**Re: Defect Information Report – Supplemental Report No. 4
08V-269, FL-530, SAF Holland ADL Suspension Weld**

Subject: RECALL 08V-269 – SAF Holland ADL Suspension Transverse Beam Weld

TRANSVERSE BEAM WELD MISLOCATION INSPECTION & INSTALLATION PROCEDURES

FIGURE 1
ADL Suspension

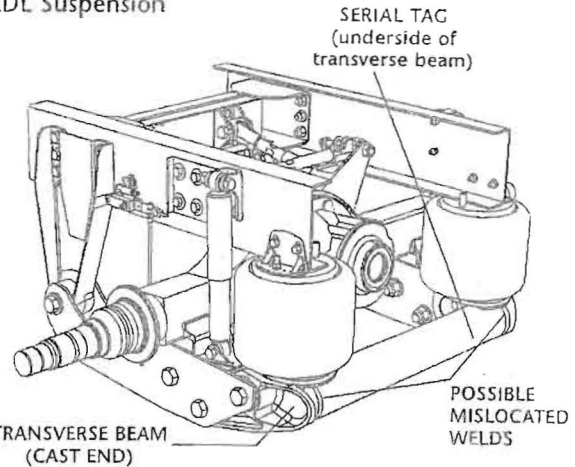
SAF-HOLLAND's ADL/ADLSD Series drive-axle suspension models may have welds that are mislocated on the transverse beam (FIGURE 1). The mislocation of these welds may diminish the strength of the transverse beam, potentially causing pre-mature failure.

FIGURE 3
Rear View of Suspension Transverse Beam

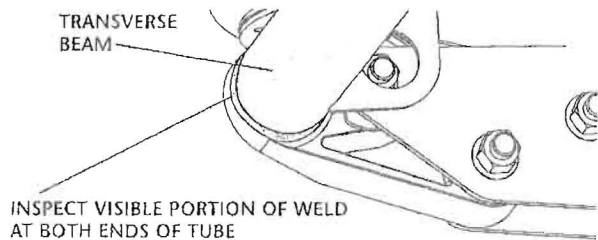
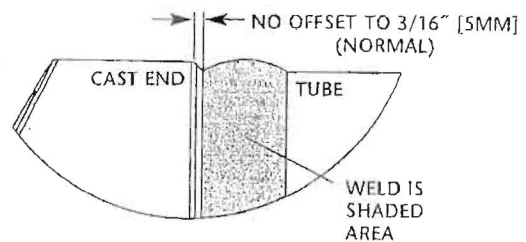
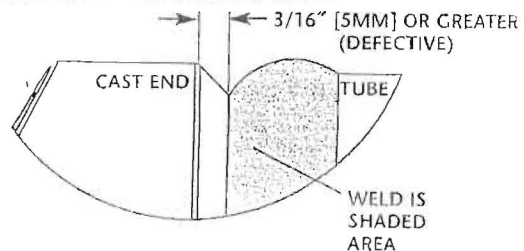
IMPORTANT: There are two weld joints where defects may have occurred on the transverse beam. A joint at each end of the beam connects a cast end to the beam's tube structure (*FIGURE 3*). Welds at these joints are a circular band that go completely around the circumference of the tube (*FIGURE 3 DETAIL A*).

5. Visually inspect each weld joint at each end of the transverse beam (*FIGURE 3*). YOU MUST REPLACE THE BEAM IF MISLOCATED WELDS ARE PRESENT. DO NOT ATTEMPT TO REPAIR MISLOCATED WELDS. *FIGURES 4* and *5* are close up views of the correct and mislocated weld profiles.
